# Orbion Bowl – Sightline Study

Testing sightline collisions for a proposed extra rows in the upper tier hall.

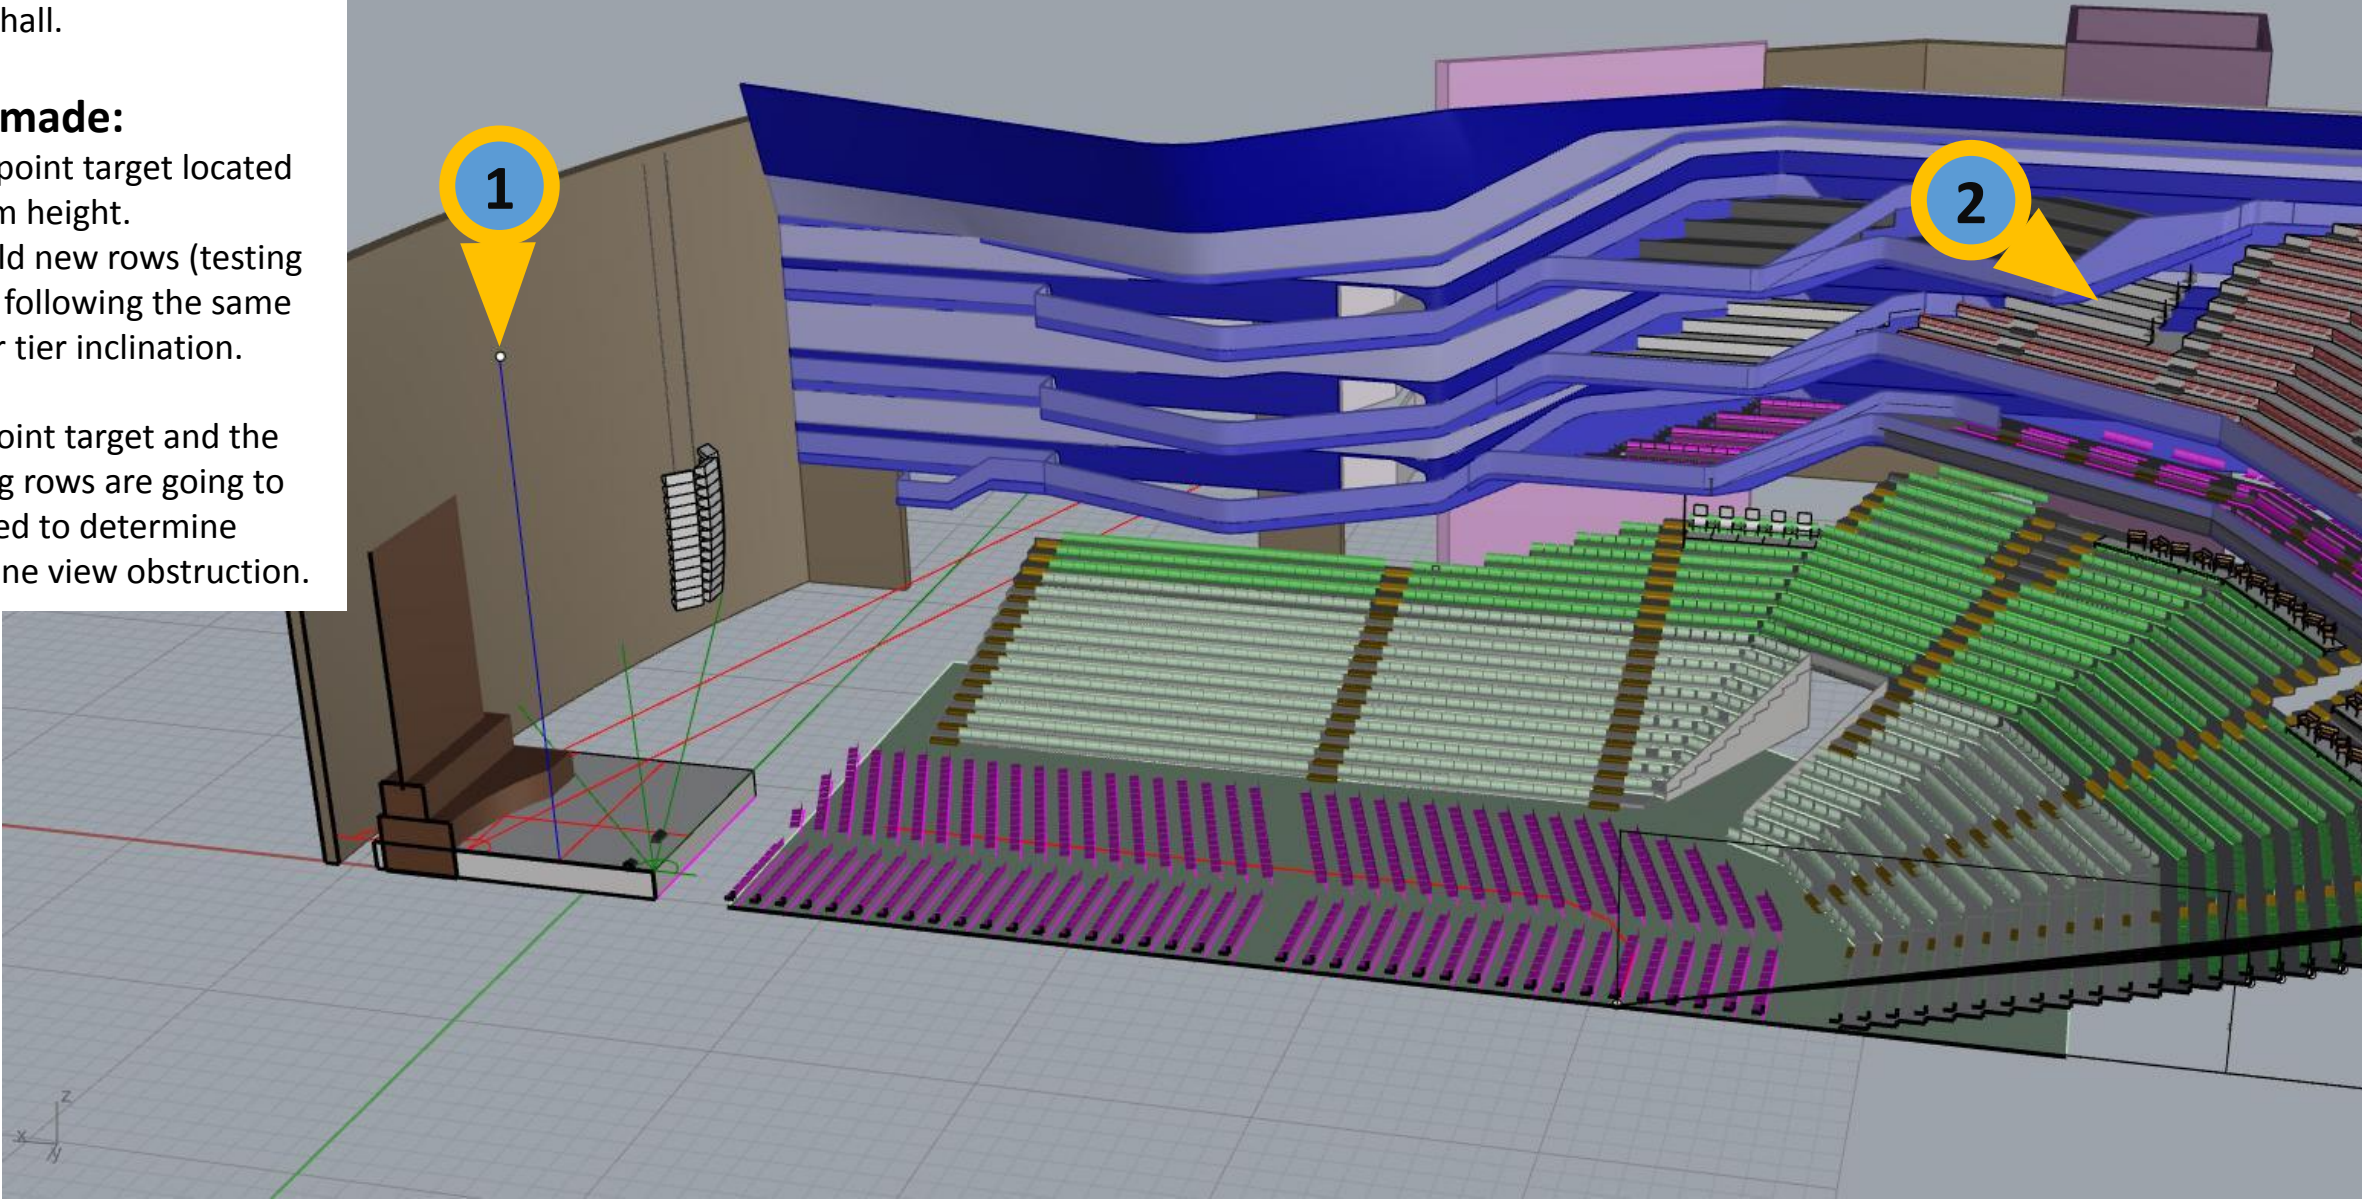
1. View point target located at 22m height.
2. Rebuild new rows (testing rows) following the same Upper tier inclination.

- The point target and the testing rows are going to be used to determine sightline view obstruction.

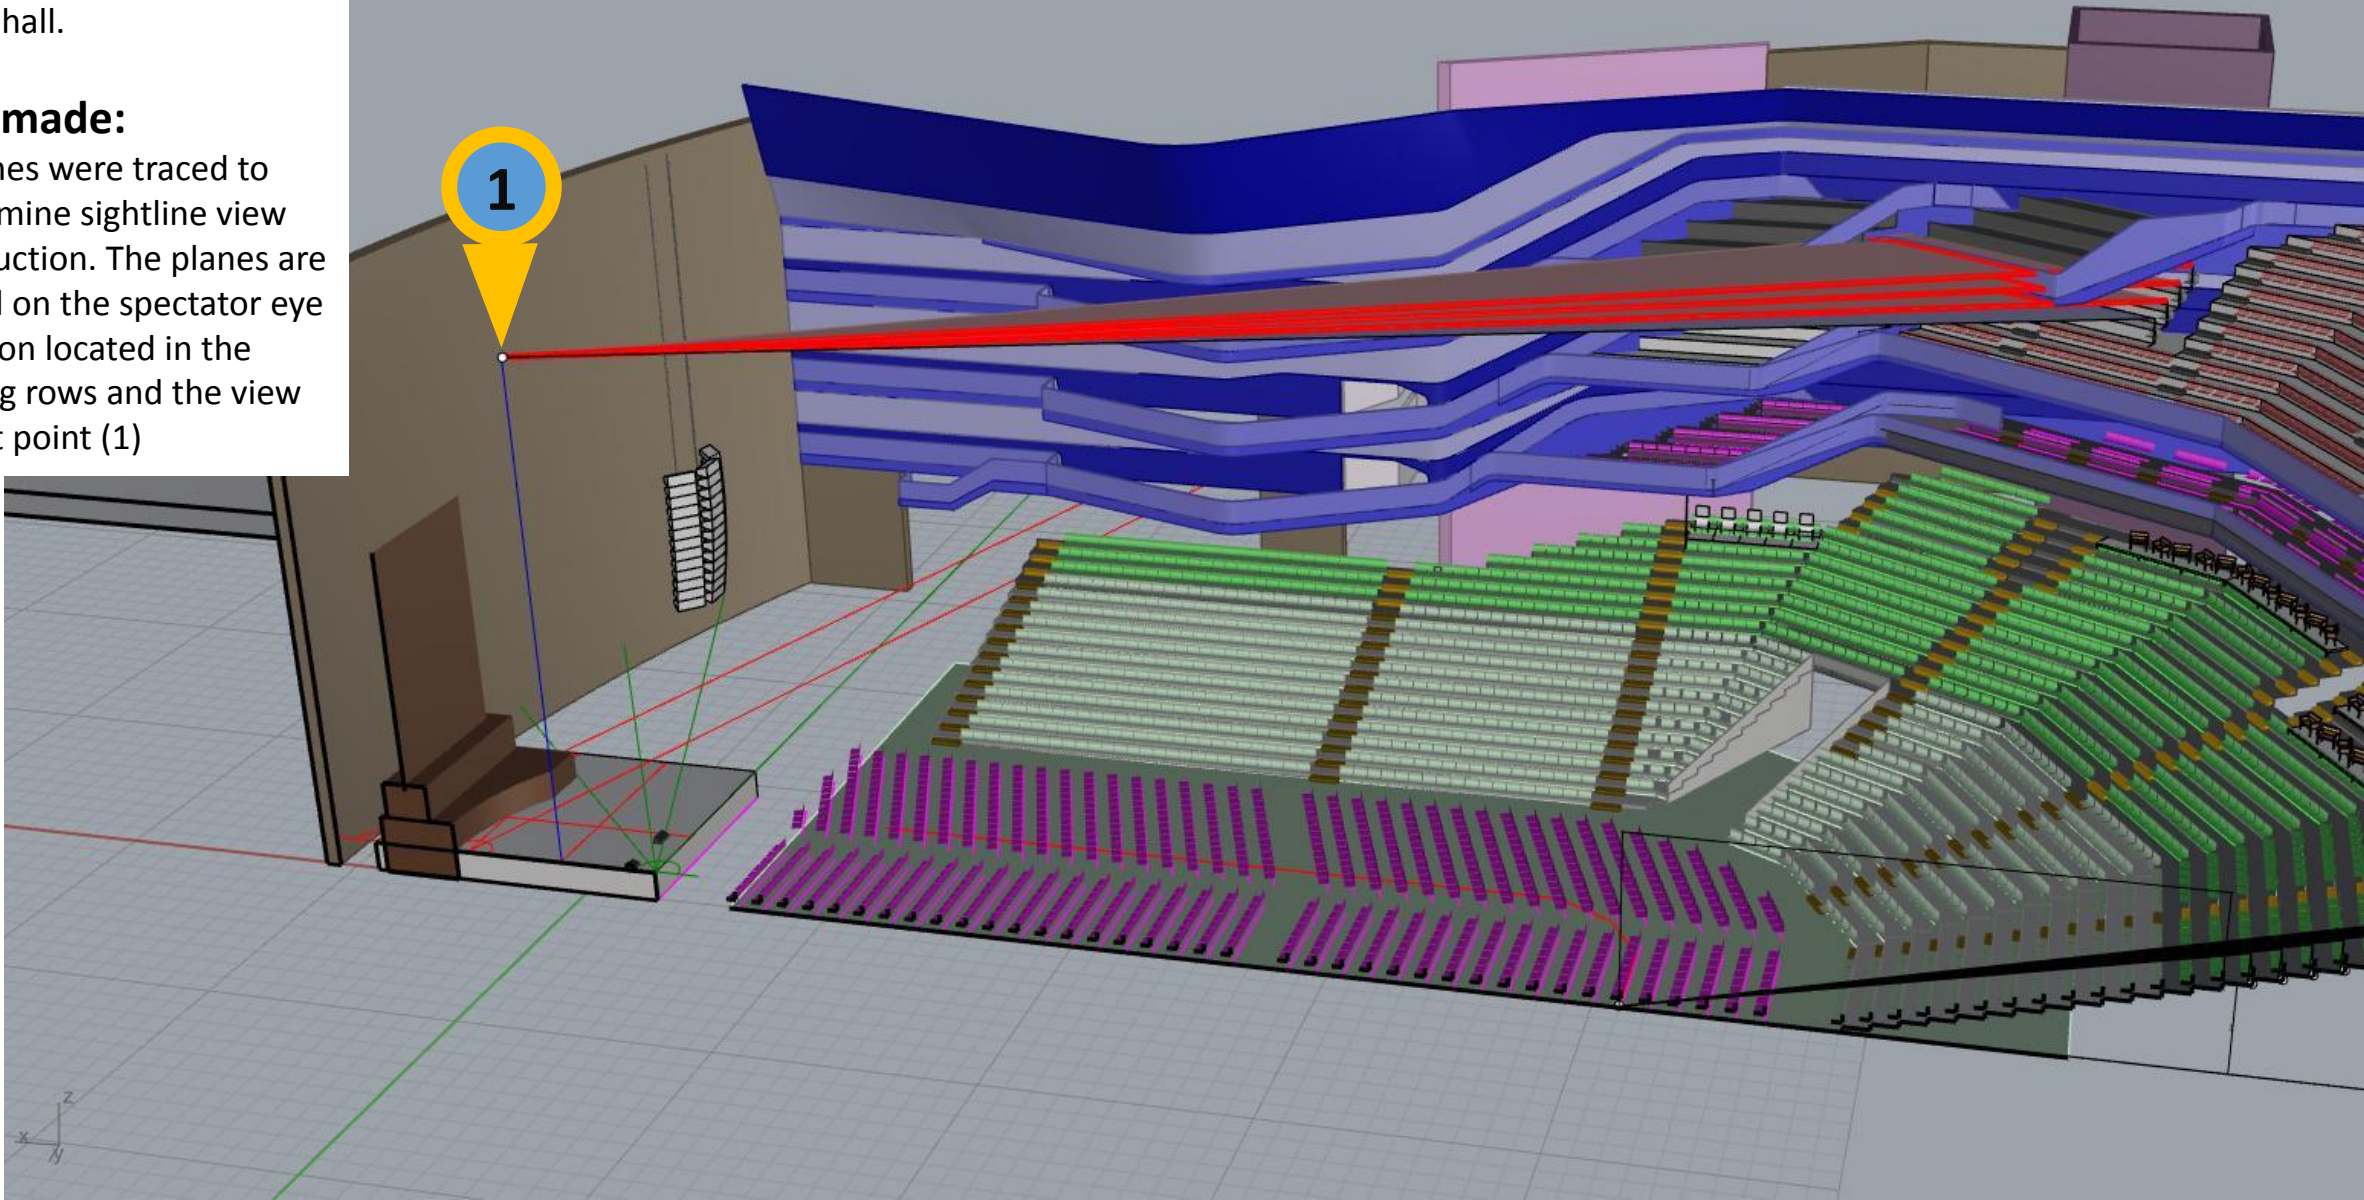
- 4 planes were traced to determine sightline view obstruction. The planes are based on the spectator eye position located in the testing rows and the view target point (1)

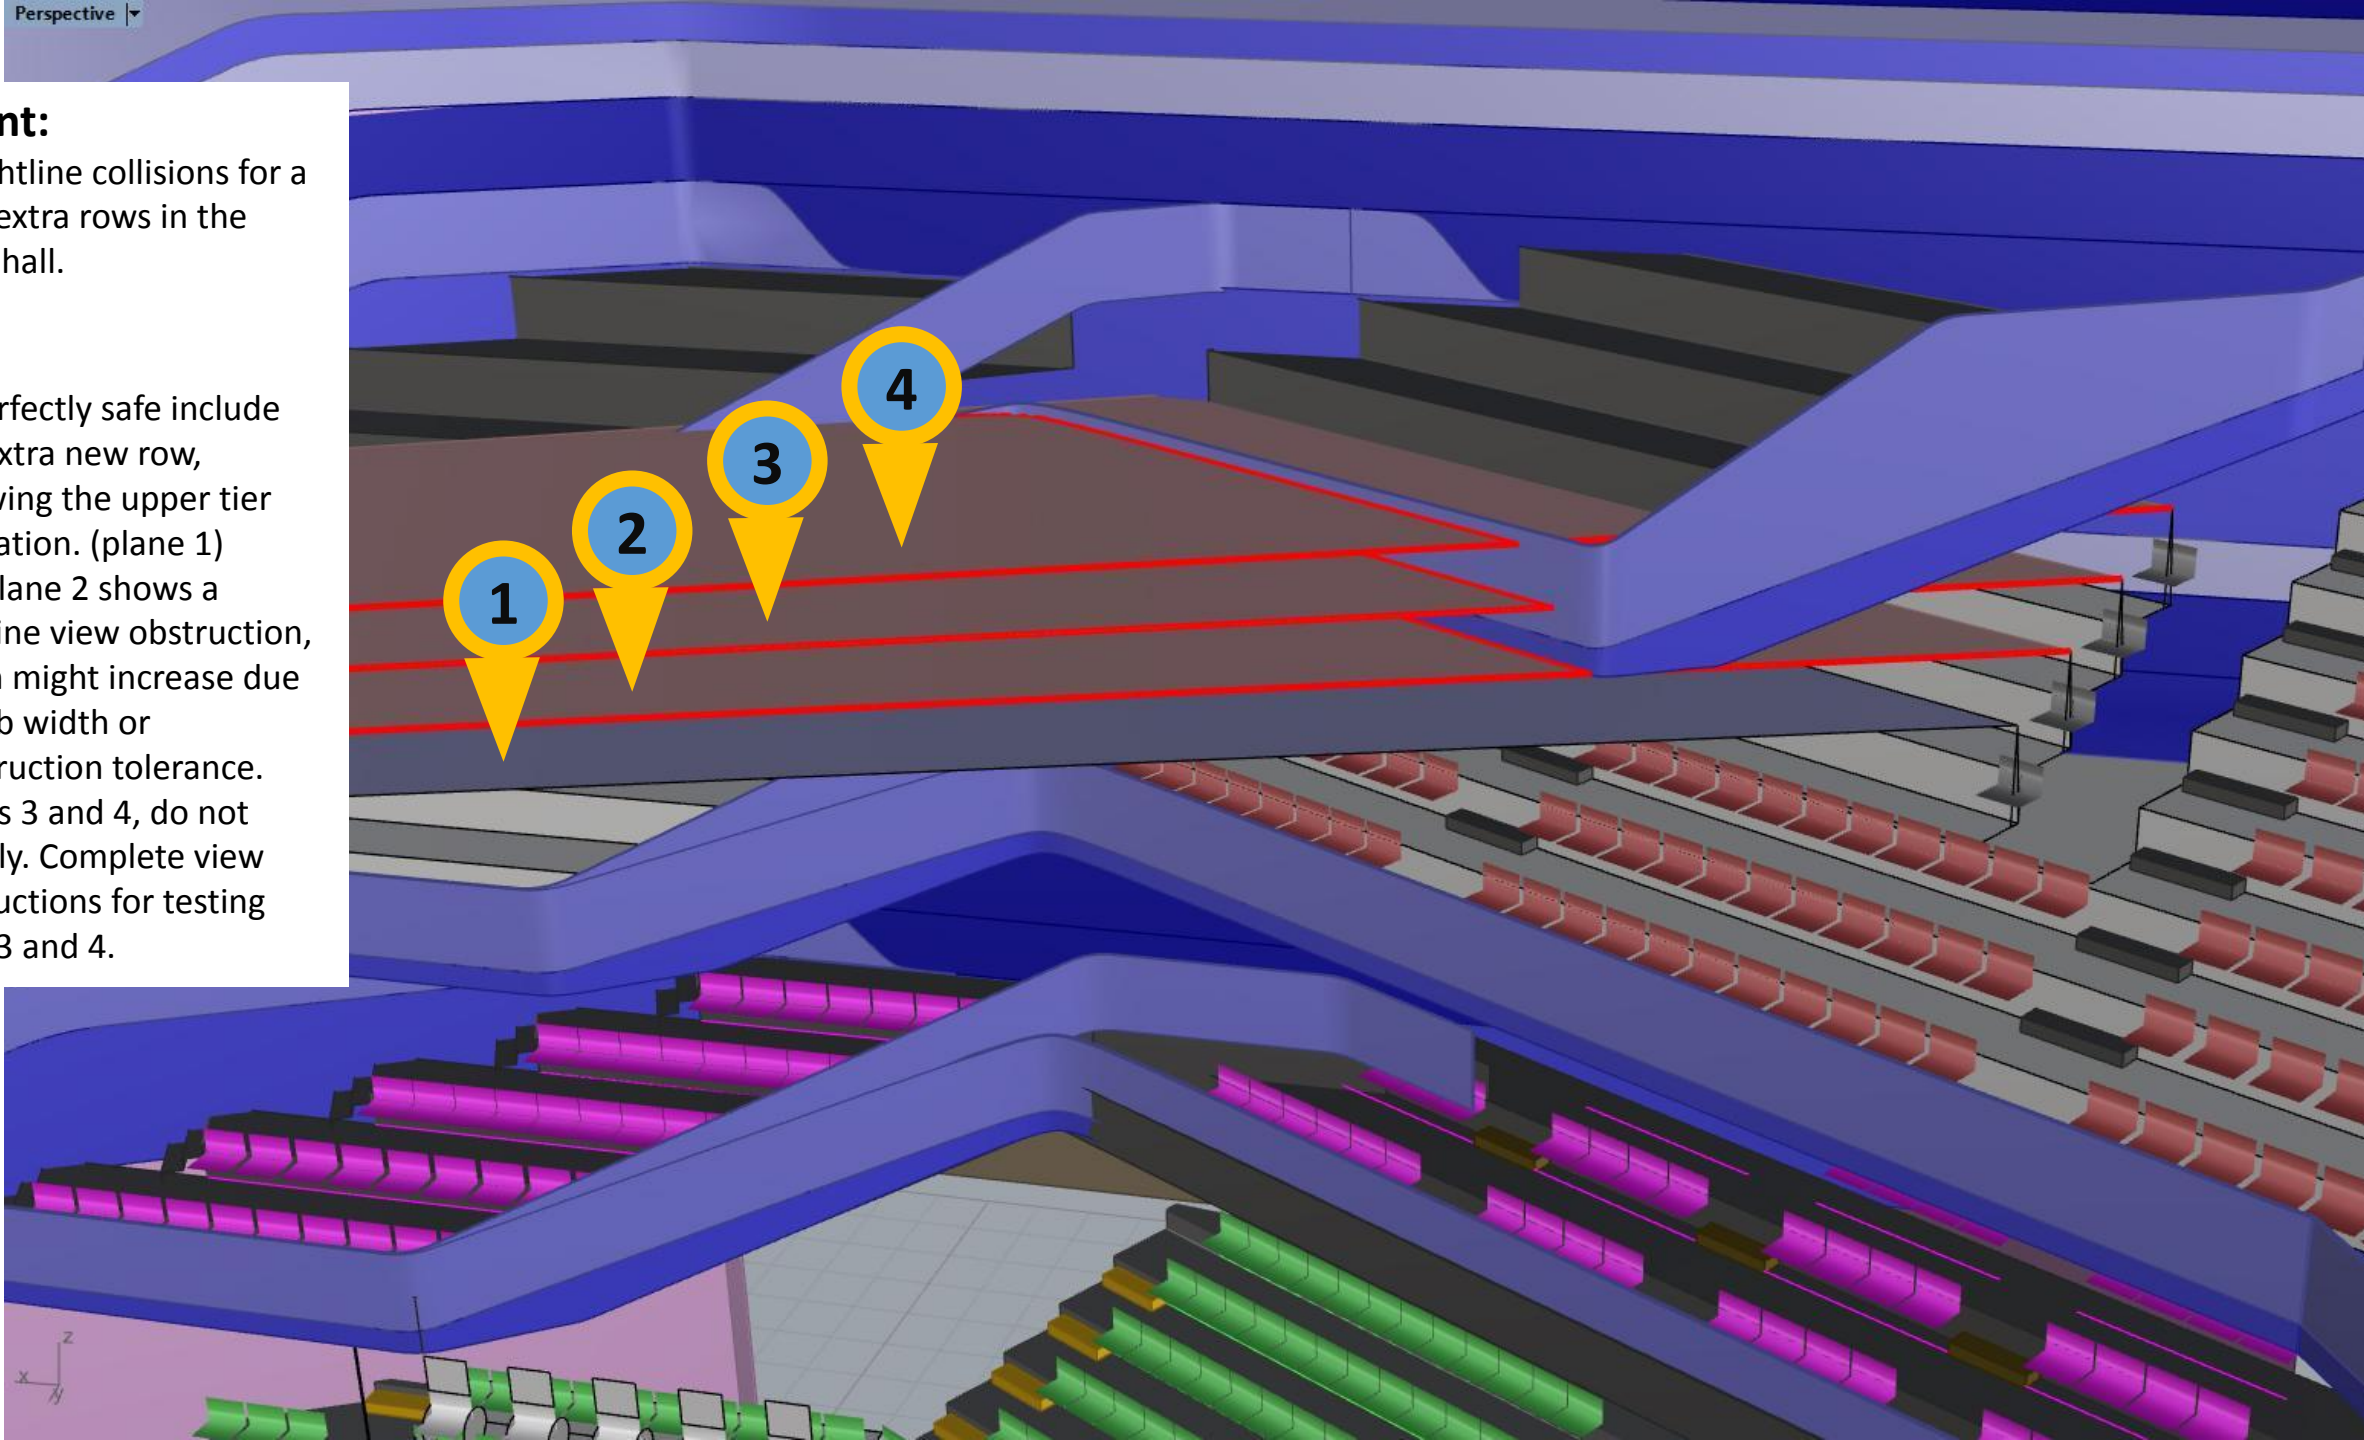
1. Its perfectly safe include and extra new row, following the upper tier inclination. (plane 1)
2. The plane 2 shows a sightline view obstruction, which might increase due to slab width or construction tolerance.
3. Planes 3 and 4, do not comply. Complete view obstructions for testing rows 3 and 4.

- Some shows will use the whole stage and it is necessary to avoid any restrictive view seats. Therefore, We do not recommend add more rows in the upper tier hall. Nevertheless, one (1) extra row in the upper tier hall is possible without sightline obstructions.
- If a second row is included in the upper tier hall. the ticket might include a warning: "restrictive view seat"
